HISTORIC AND DESIGN REVIEW COMMISSION

August 05, 2020

HDRC CASE NO: 2020-329
ADDRESS: 114 CAMP ST
LEGAL DESCRIPTION: NCB 2561 BLK 4 LOT 5 THRU 11 SAVE & EXCEPT IRR 95 SQ FEET OF LOT 11 & W 7 FT OF ALLEY **MASTERFILE CAMP STREET RESIDENCES CONDOMINIUMS
ZONING: IDZ, H, RIO-7D
CITY COUNCIL DIST.: 1
LANDMARK: Individual Landmark
APPLICANT: Kristen Weber/Don B McDonald Architect
OWNER: Rick Liberto/CAMP STREET RESIDENCES CONDOMINIUM ASSOCIATION
TYPE OF WORK: Exterior alterations
APPLICATION RECEIVED: July 08, 2020
60-DAY REVIEW: Not applicable due to City Council Emergency Orders
CASE MANAGER: Edward Hall
REQUEST:

1. Modify the south façade by removing two existing windows and a portion of the wall to restore the original opening, as noted on the original construction documents.
2. Install new steel doors on the south façade.
3. Install a new balcony on the south façade to align with and match the existing balcony immediately above the proposed location.

PROPOSED REMOVAL OF 2
EXISTING WINDOWS TO ALLOW FOR
NEW EXTERIOR DOOR

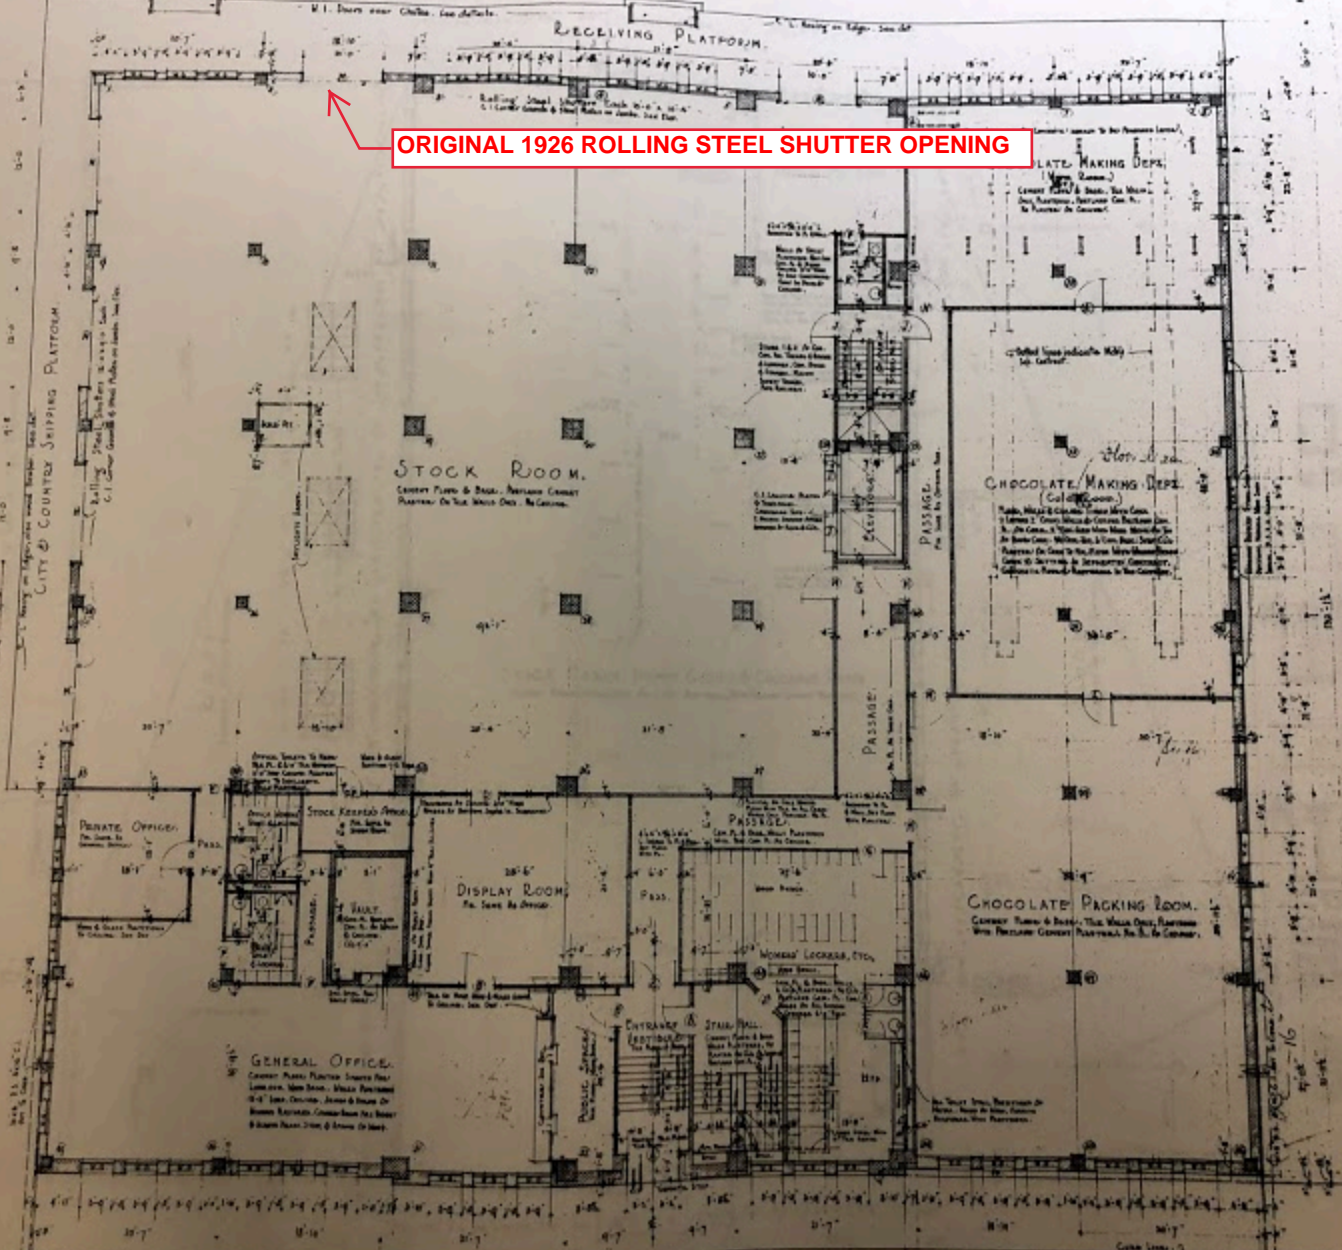
- b. SOUTH FAÇADE MODIFICATIONS – The applicant has proposed to modify the south façade by removing two existing windows and a portion of the wall to restore the original opening, as noted on the original construction documents. The applicant has provided the original construction documents noting the original opening. Staff finds the proposed modifications to be appropriate.

Staff recommends approval as submitted based on findings a through d.

1 Demo Plan 1st Floor

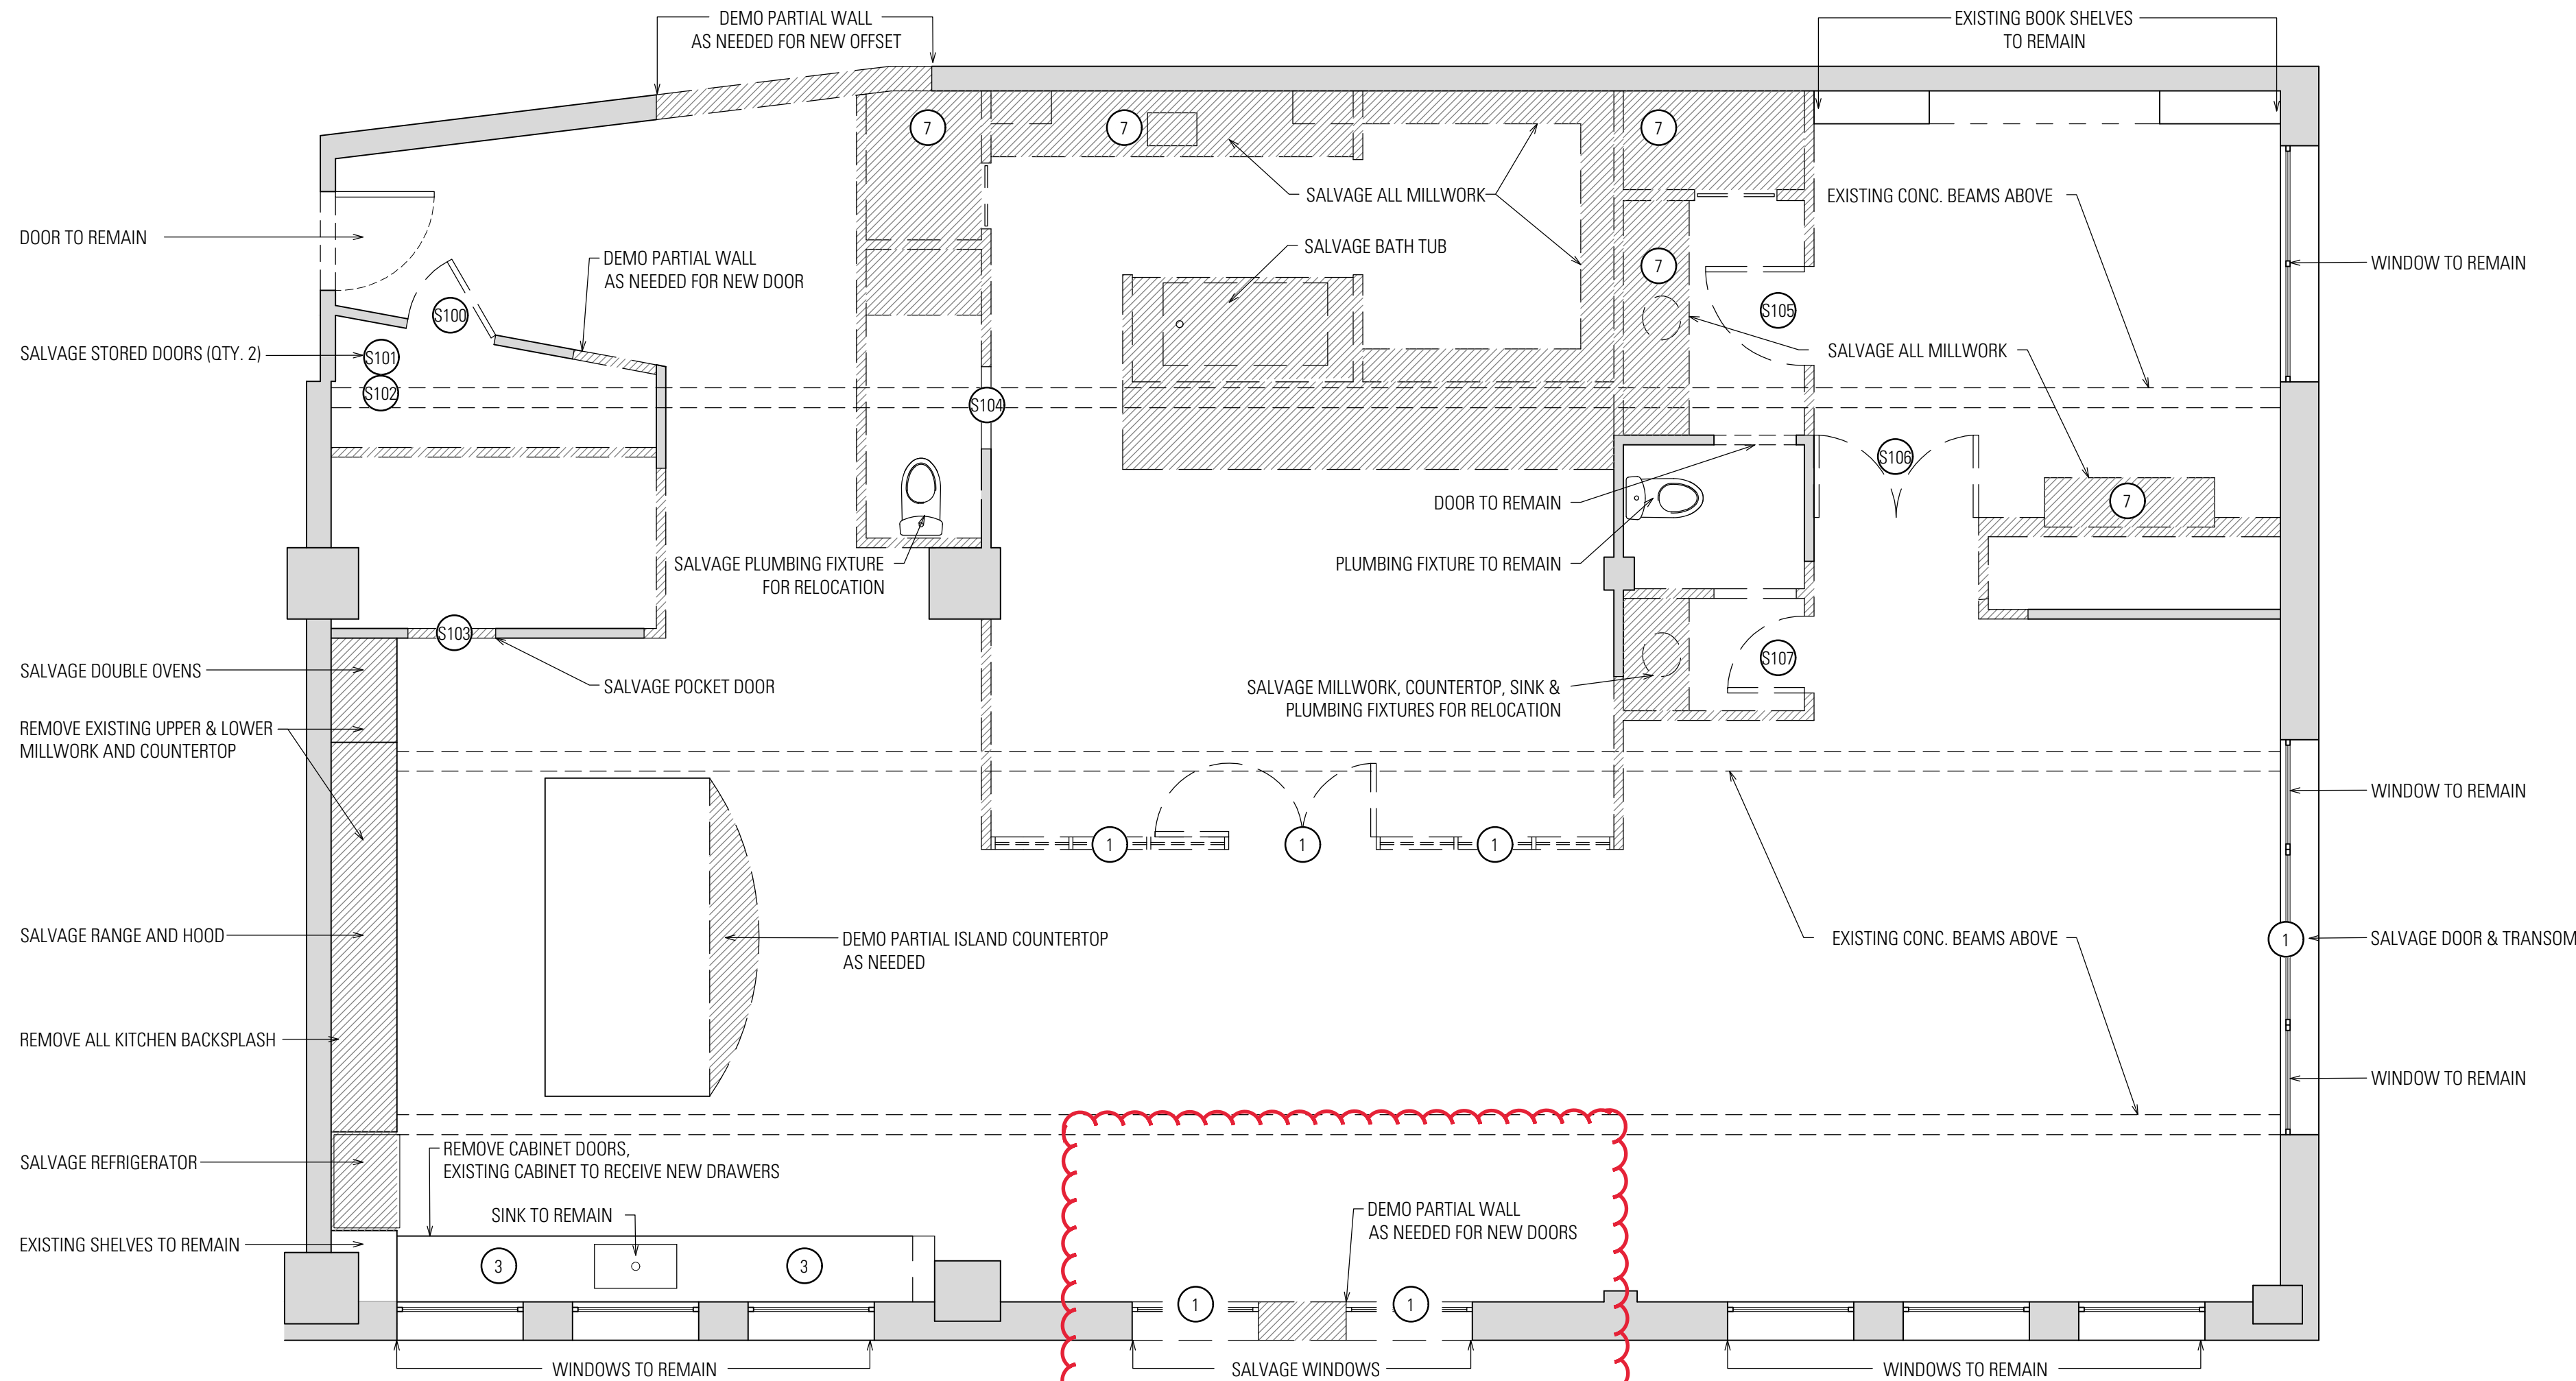
PROPOSED REMOVAL OF 2 EXISTING WINDOWS
TO ALLOW FOR NEW EXTERIOR DOOR
